SUBJECT: Quincy Regional Airport
Quincy, Illinois
Adams County
Illinois Project Number: UIN-5025
AIP Project Number: N/A
Contract No. QI065
Item No. 06A, June 17, 2022 Letting
Addendum A

NOTICE TO PROSPECTIVE BIDDERS

Reason for Addendum:

Provide end area earthwork calculations for landside improvements.

CG802

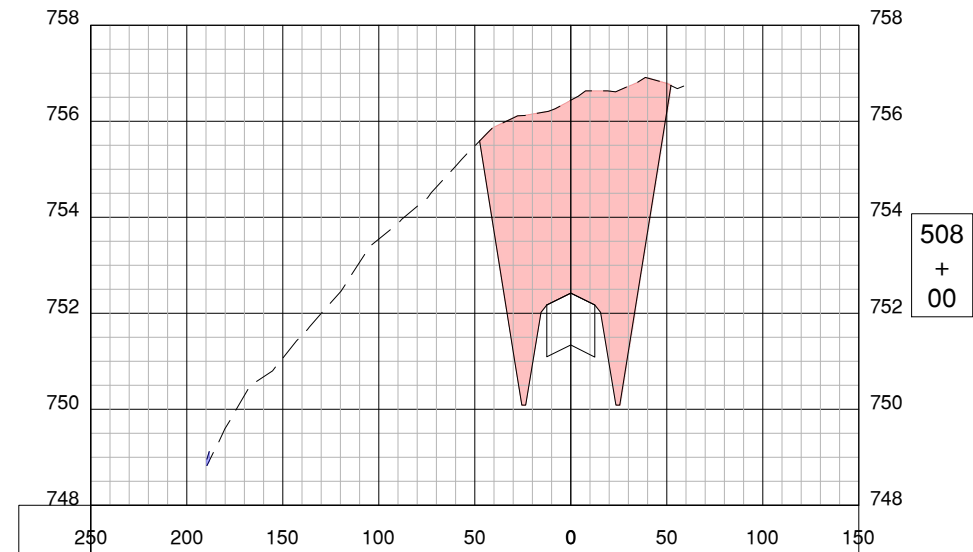
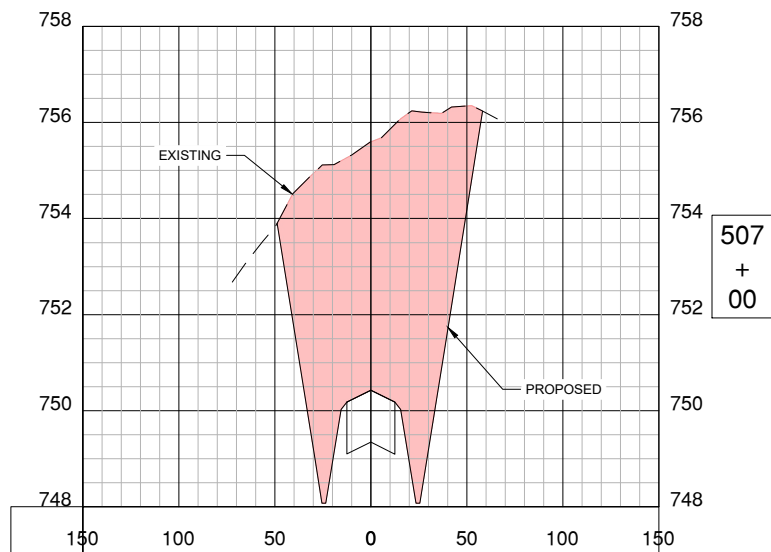
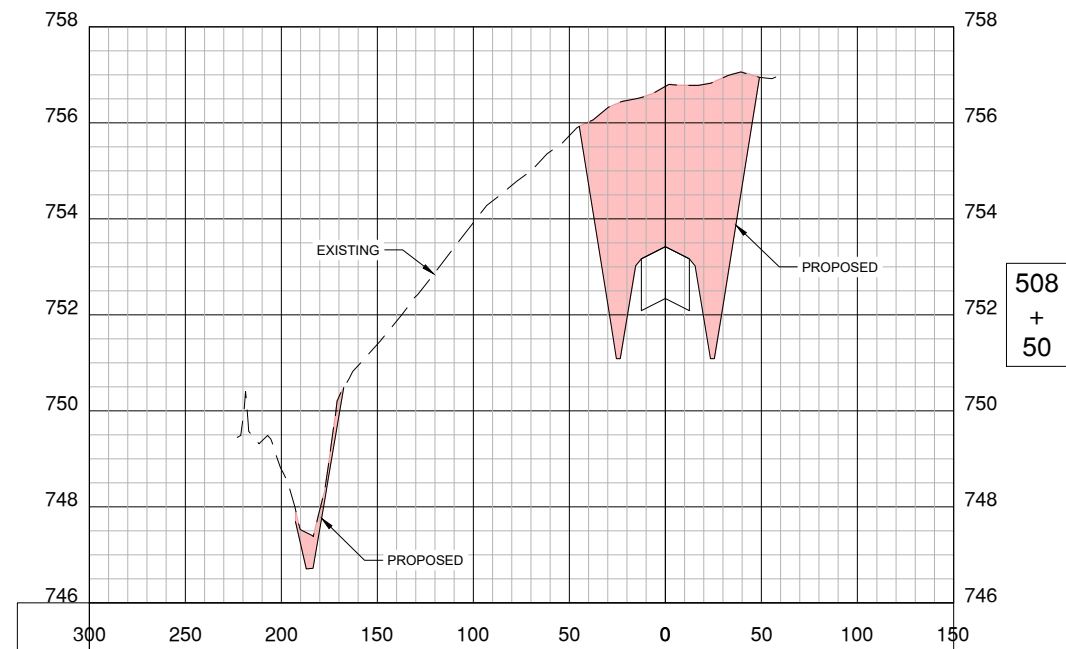
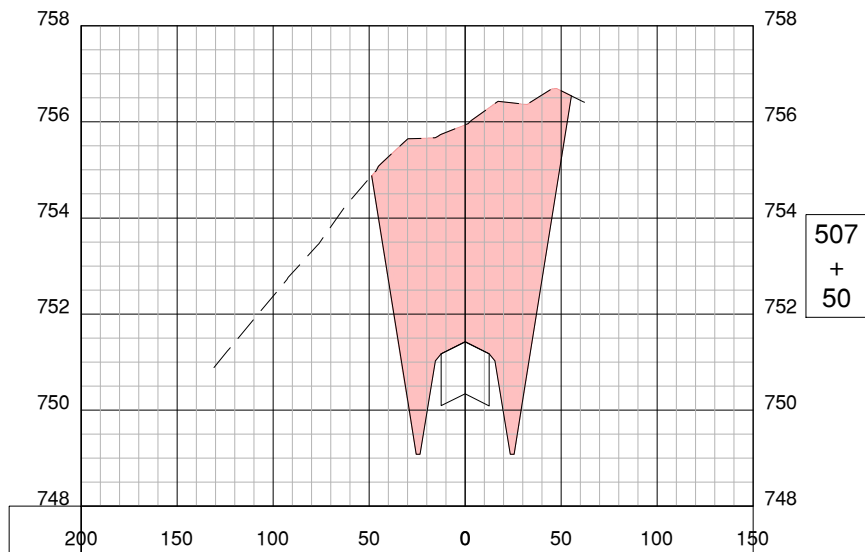
1. Add cross section sheets with end area calculations for the landside improvements.
2. Adjust quantity of Unclassified Excavation.

1. REVISE QUANTITY: Sheet 2, Pay Item AR152410, from 19,250 cy to 27,600 cy.
2. REMOVE: Sheets 49 and 50.
3. ADD: Sheets 49 – 55 (attached).
